Access Compliance Report Public Rights-of-Way (Curb Ramps)

Intersection ID: 52288Main Street:STEELE_CREEK_RDCross Street:DIXIE_RIVER_RDLocation:SWADA ID: 8032A6B341BERamp Type:ParaInitial Pass/Fail:FailOverall Compliance:NoSeverity Score:1.25

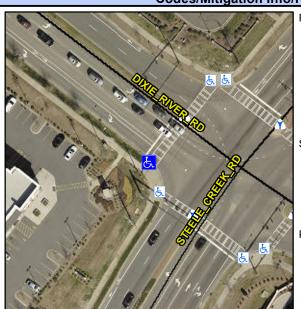
Possible Solutions:						
Remove & Replace Entire Ramp.						
Surveyor Notes:						
N/A						
PDOW/ADA						
R304.5.3						
PROW/ADA: R304.5.3

Comp	liance Description	Data	omponent Compliance Compliance Description			Data
N/A	Ramp Length LT (in)	57.0	N/A		Length RT (in)	65.0
Yes	Ramp Width LT (in)	90.0	Yes		Width RT (in)	93.0
Yes	Ramp Slope LT (%)	5.8	Yes	•	Slope RT (%)	8.2
No	Ramp XSlope LT (%)	2.2	No	•	XSlope RT (%)	2.2
N/A	Landing Length (in)	N/A	N/A	•	Provided?	N/A
N/A	Landing Width (in)	N/A	N/A		Contrast?	N/A
N/A	Landing Slope (%)	N/A	N/A		Length (in)	N/A
N/A	Landing X Slope (%)	N/A	N/A		Full Width?	N/A
N/A	Landing X Slope (%) Landing Curb? (Y/N)	N/A	N/A		Offset (in)	N/A
N/A	Shared Landing?	N/A N/A	IN/A	DWS	Oliset (III)	N/A
N/A	ŭ	N/A N/A	N/A	Cutto	r Clana (0/)	N/A
	Gutter Ponding?				r Slope (%)	
N/A	Gutter Lip Ht (in)	N/A	N/A		r X Slope (%)	N/A
N/A	Painted X Walk1?	Yes	N/A		ed X Walk2?	N/A
	X Walk 1 Direction	To NE			k 2 Direction	N/A
N/A	X Walk 1 Width (in)	111.0	N/A		k 2 Width (in)	N/A
	X Walk 1 Slope (%)	2.2			k 2 Slope (%)	N/A
	X Walk 1 X Slope (%)	0.1		X Wal	k 2 X Slope (%)	N/A
